Project: Hot Springs National Park – Rehabilitate Bathhouses – Buckstaff Bathhouse

Submittal: Scroll Water Chiller (CH-1) (Re-Submittal #1)**Submittal Number:** 236413.001

Spec Section: 236413

Drawing # and Installation Location: M3-2

Piping Layout for Installation of Remote Evaporator/Condenser Chillers

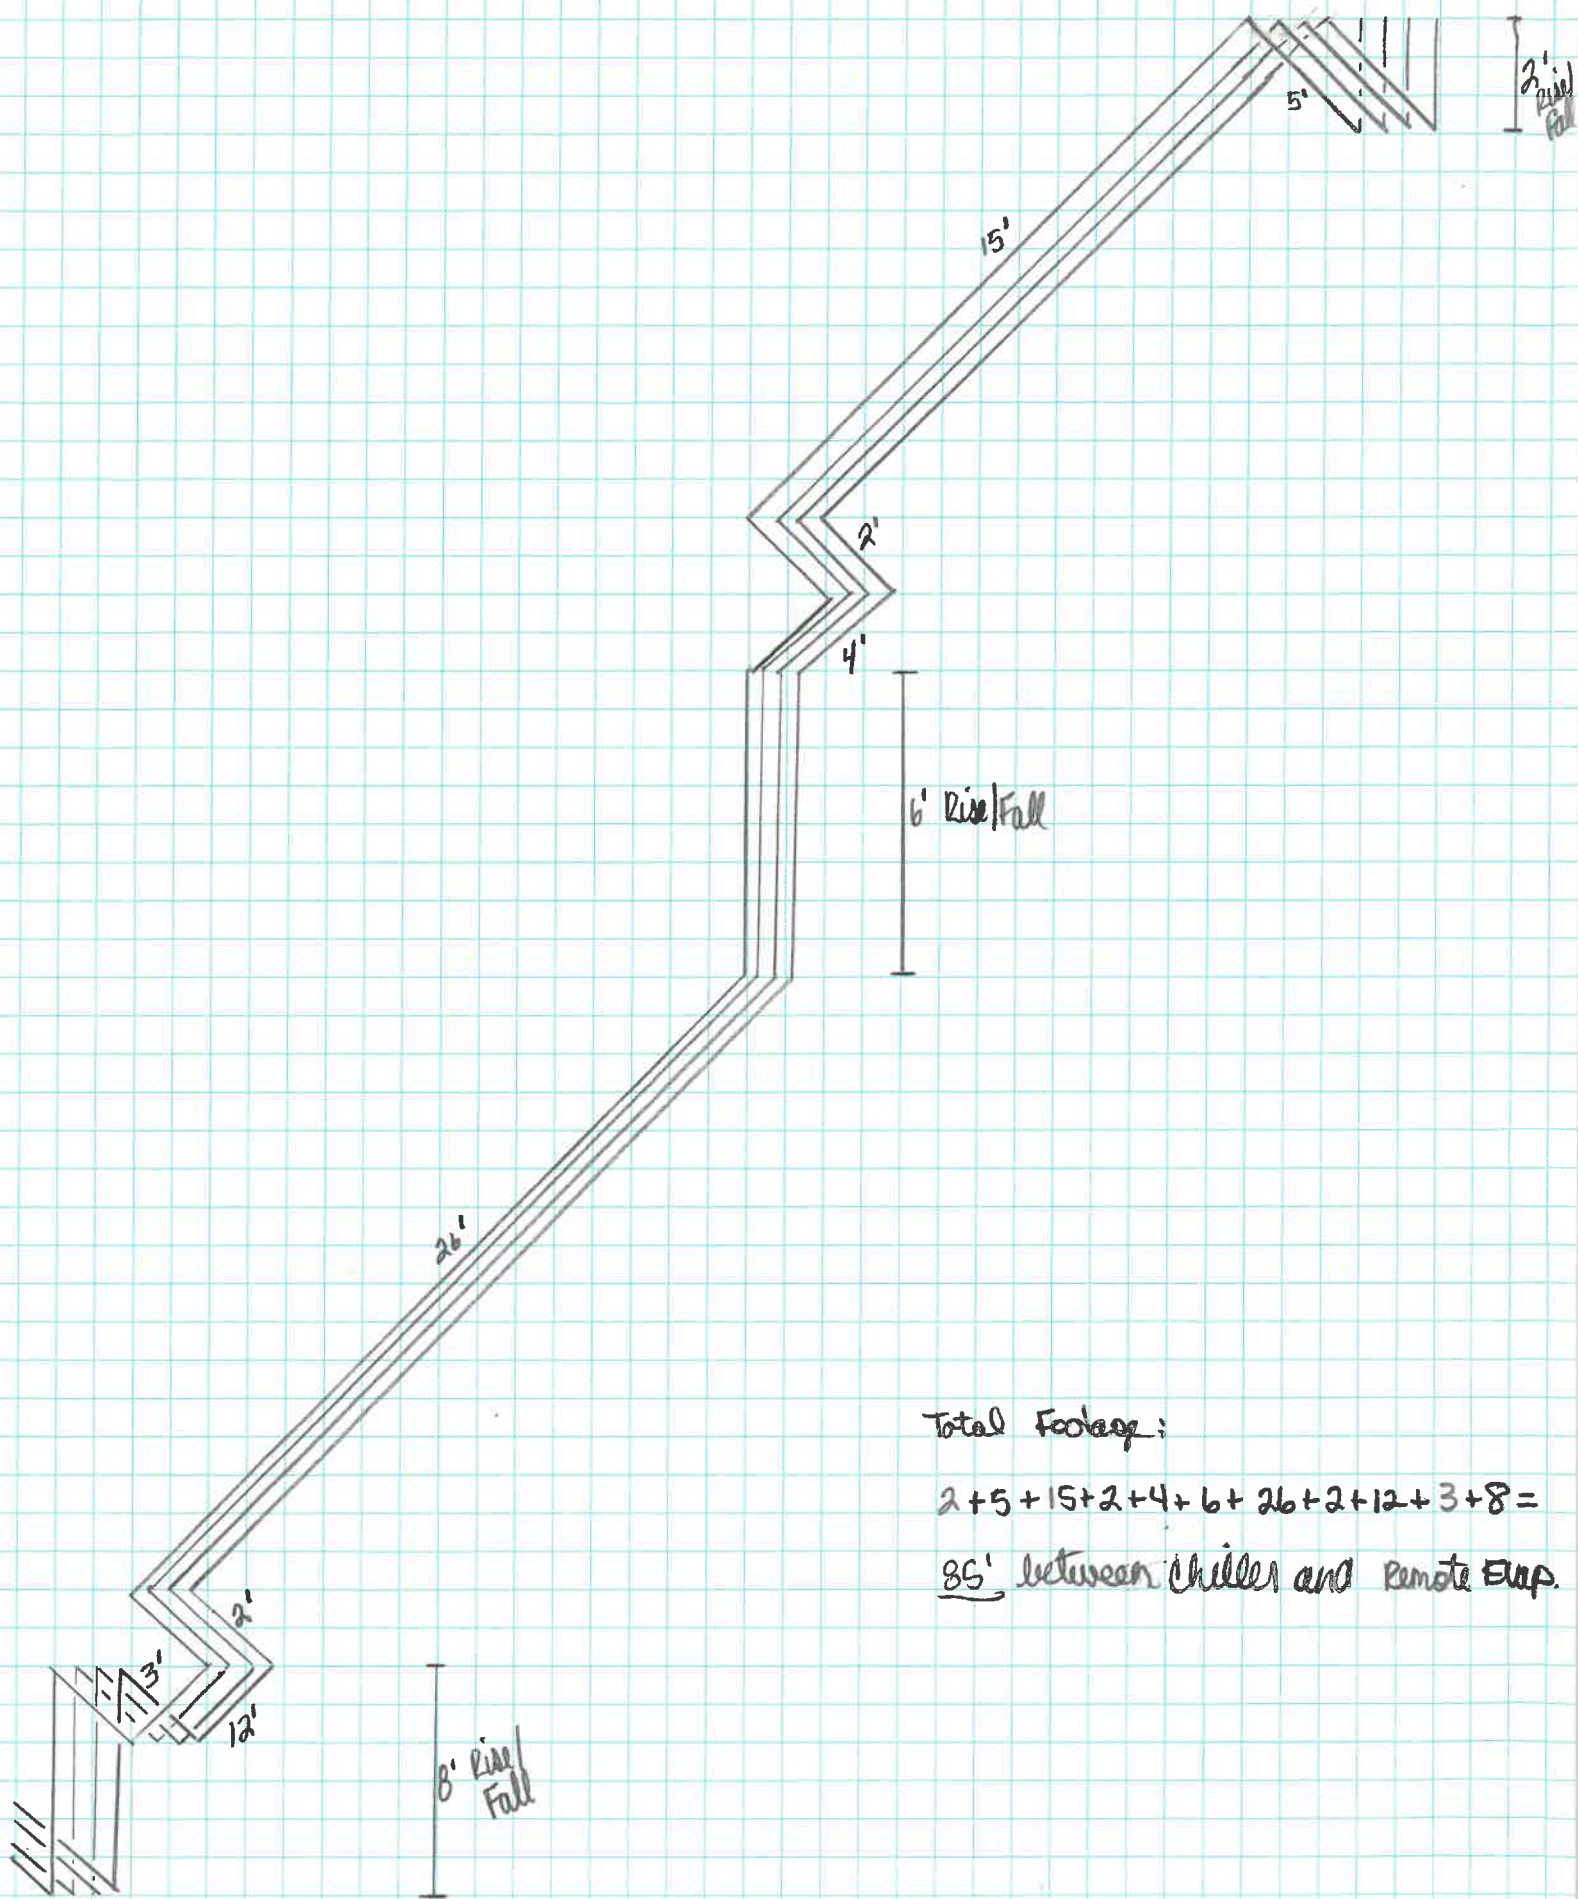
CKT-1 & 2 Liquid Lines = 1-1/8" | CKT-1 Horizontal Suction Lines = 2-1/8" | Vertical Suction Lines = 1-5/8" | CKT-2 Horizontal and Vertical Suction Lines 1-5/8"

See Marked Drawing for trap locations. Slope all refrigerant piping in the direction of flow.

*Liquid lines should be 1-1/8 " on the circuit based on ~ 110 ' total Equiv. length

*Horizontal Suction lines should be 2-1/8 " based on the circuit based on ~ 130 ' total Equiv. length

*Vertical Suction lines should be 1-5/8 " based on the maximum suction riser line size for vertical upflow.

*Liquid lines should be 1-1/8 " on the circuit based on ~ 110' total Equiv. length

*Horizontal Suction lines should be 1-5/8 " based on the circuit based on ~ 124 ' total Equiv. length

*Vertical Suction lines should be 1-5/8 " based on the maximum suction riser line size for vertical upflow.

Note: Add Trap (3x 90L elbows) at the bottom of the 6.0' Vertical Rise of Circuit 1. Add Trap (3x 90L elbows) at the bottom of the 6.0' Suction Vertical Rise of Circuit 2.
